1.General Comments:

Jin et al. clearly define the issue at hand and how they have contributed to the solution and what the resulting benefits are to science and society; namely, that common biomass burning emission inventories often omit diurnal information and vertical injection heights of fires, and that by incorporating their ideas, they have an emissions product for Southeast and East Asia (SEAF) that includes these two important pieces of information that ultimately improves the accuracy of models used for reporting and assessment of air quality, climate and public policy. They have done careful work to compare their results with measurements from TROPOMI, MISR and CALIPSO, and they present a comparison of their emissions dataset with common established BB emission datasets.

Figure 4

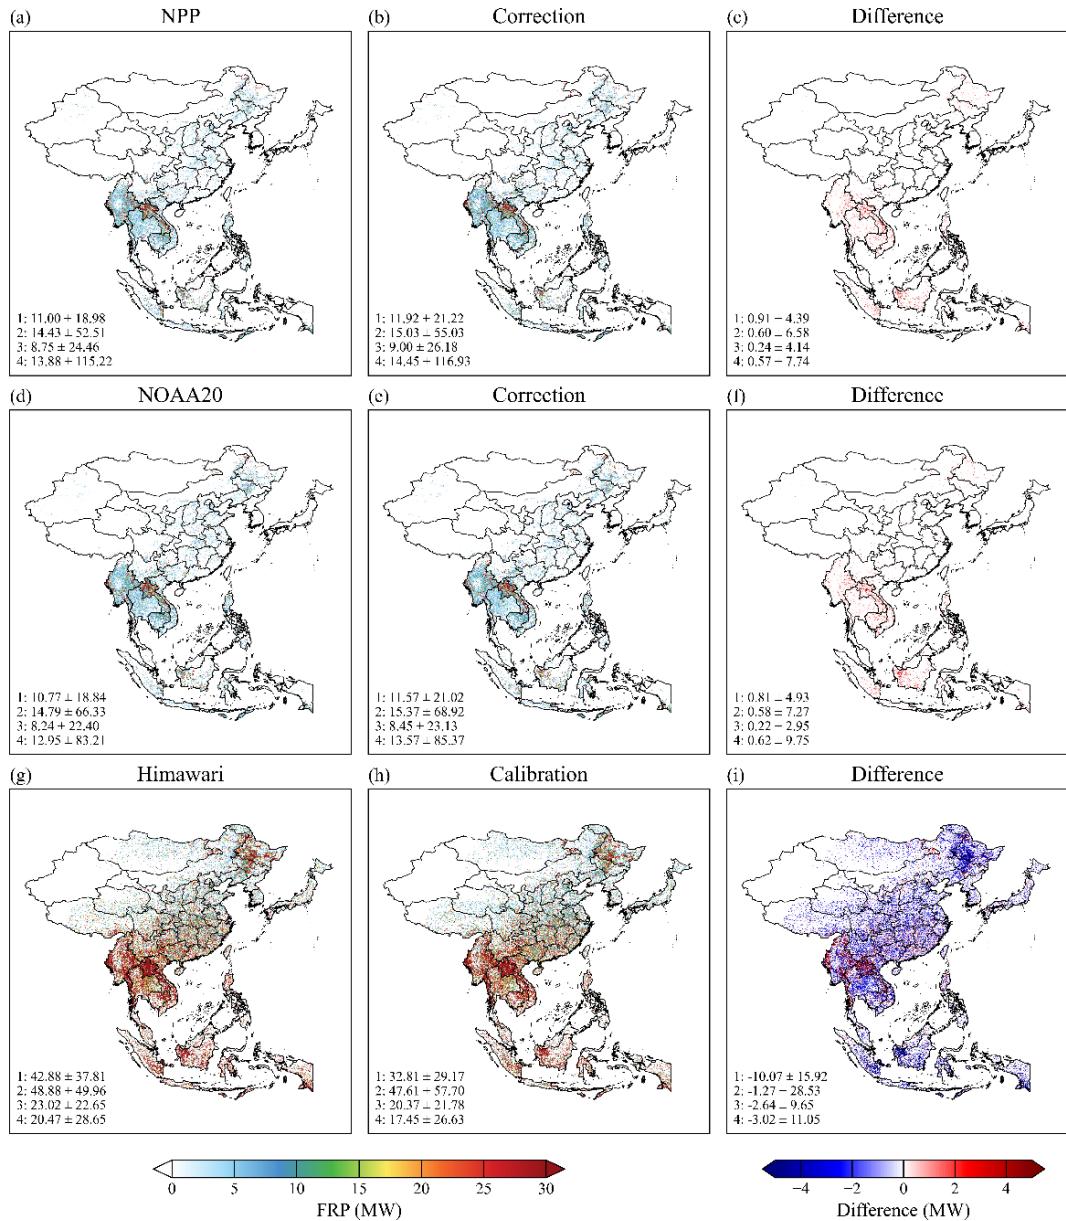
- 16.** Fig. 4: Please explain how the cloud-corrected AHI FRP data can be less than the non-cloud-corrected data.

- 17.Figs. 4, 7 & S7b: The resolution of the images seems to be too coarse. There appears to be a gridded/stripped pattern in the images – it appears to be an artifact in the data (particularly in Fig. 7), but it could just be the poor image resolution. Please update the resolution – I would like to be able to see more detail when I zoom in. Please also confirm what the stripped pattern is if it is indeed an artifact.

Response: Thank you for raising this important point. We clarify that the “correction” applied to AHI FRP in this study is not a pure cloud-recovery procedure and therefore does not necessarily lead to a monotonic increase in FRP. To avoid any further ambiguity, we have updated the caption of Fig. 4 to explicitly distinguish between the cloud-gap correction applied to VIIRS and the cross-sensor calibration applied to AHI.

In the revised manuscript, cloud correction is applied exclusively to VIIRS FRP to compensate for cloud-induced under-detection, whereas AHI FRP is subsequently adjusted **through cross-sensor calibration** using the cloud-corrected VIIRS product as a radiometrically more reliable reference. This calibration is designed to improve physical consistency in FRP magnitude between sensors rather than to inflate AHI-derived values. The results shown in Fig. 4 and Section 3.1 demonstrate that after cross-sensor calibration using cloud-corrected VIIRS FRP as a reference, calibrated AHI FRP exhibits region-dependent responses. In most regions, AHI FRP decreases due to suppression of sampling-related overestimation, whereas in regions with substantial BB emissions (e.g., northern Laos), AHI FRP still increases as cloud correction reveals additional fire activity previously underestimated. Therefore, calibrated AHI FRP may either decrease or increase depending on the regional balance between cloud-induced underestimation and sampling-related overestimation already documented in the manuscript.

Response: Thank you for your careful review and the opportunity to clarify our visualization approach. We have carefully examined Figs. 4, 7, and S7b regarding the "grid/stripping" patterns. We would like to clarify that these patterns are not instrumental artifacts (such as VIIRS detector striping) or algorithmic errors. Instead, they represent the native resolution of our gridded product. The "blocky" appearance is a deliberate choice for the following reasons:

- (1) Data Fidelity and Transparency: We used a pixel-wise rendering method (pcolormesh with no interpolation). This ensures that each pixel's color accurately represents the underlying aggregated FRP value. Spatial interpolation (smoothing) often creates a false sense of continuity, which can misrepresent the magnitude of fire intensity and artificially "smear" fire signals into non-fire areas.
- (2) Product Characteristics: Since the data is aggregated into a regular $0.03^\circ \times 0.03^\circ$ grid, the boundaries between grid cells are inherently discrete. The "striping" the reviewer observed is the alignment of these discrete grid cells at the boundaries of fire plumes.

Figure 7

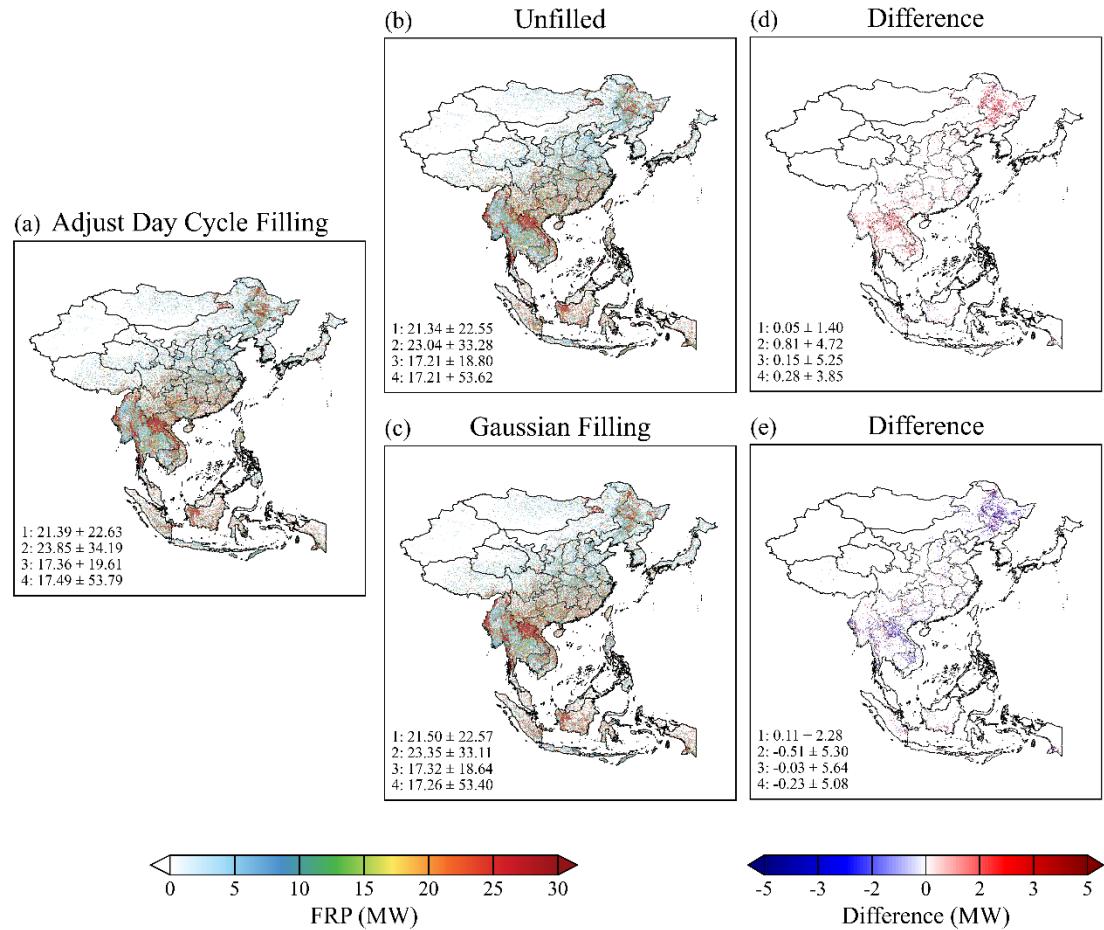
- 14.Lines 419-440 / Fig. 7: The differences between the original and filled mean FRP values are so low compared with their standard deviations that it's hard to argue for the significance of these changes. Please address this. Also, do I understand correctly that the conventional Gaussian fits result in lower FRP for most of the regions? How did you define the conventional fit? If simply by not using GLS and GVM, then would you mind mentioning how e.g. Ellicott et al. 2009, Zheng et al. 2021, and Andela et al. 2015 all have dynamic diurnal Gaussian fits that change amplitude and/or duration with each day's data, and how you are similar or different in your approach.

Response: We thank the reviewer for this insightful comment. We address below the interpretation of the mean FRP differences in Fig. 7, the definition of the conventional Gaussian fit, and the relationship between our approach and previously published dynamic diurnal Gaussian methods.

(1) Interpretation of small mean differences relative to standard deviations: The relatively small changes in mean FRP compared with the large standard deviations shown in Fig. 7 do not indicate weak correction. Rather, they reflect the conservative nature of the reconstruction and the fact that the standard deviation primarily represents intrinsic spatiotemporal fire variability across heterogeneous fire regimes, rather than reconstruction uncertainty. In other words, the standard deviation shown in Fig. 7 is dominated by real fire intermittency and regional heterogeneity, not by the magnitude of the applied correction. Fig. 7 illustrates two opposing systematic effects: missing observations during sustained high-burning periods lead to systematic underestimation in the unfilled product, while unconditional application of diurnal Gaussian curves over a full 24-hour cycle tends to introduce artificial FRP during low- or non-burning periods. The modest net change in the mean therefore reflects bias redistribution, whereby underestimation during active burning windows is reduced while overestimation during inactive hours is suppressed. As a result, statistical significance should not be assessed solely by the ratio of mean change to standard deviation, because the correction targets systematic temporal bias rather than overall variance reduction.

(2) Definition and behavior of the conventional Gaussian fit: In this study, the “conventional Gaussian fit” refers to a static climatological diurnal curve derived from long-term averages and applied uniformly across the entire 24-hour cycle without conditioning on event duration, high-burning probability windows, or observation availability. This definition intentionally mirrors the most common implementation of climatological Gaussian gap filling used in many FRP-based emission frameworks. Under this definition, the conventional fit can yield either higher or lower regional mean FRP depending on the balance between recovered emissions during active periods and artificially assigned emissions during inactive periods. In several regions, the latter effect dominates, resulting in lower or even negative net corrections relative to the dynamically adjusted reconstruction shown in Fig. 7. This explains why the conventional

Gaussian approach produces lower FRP estimates for most regions in Fig. 7, despite partially filling missing observations.
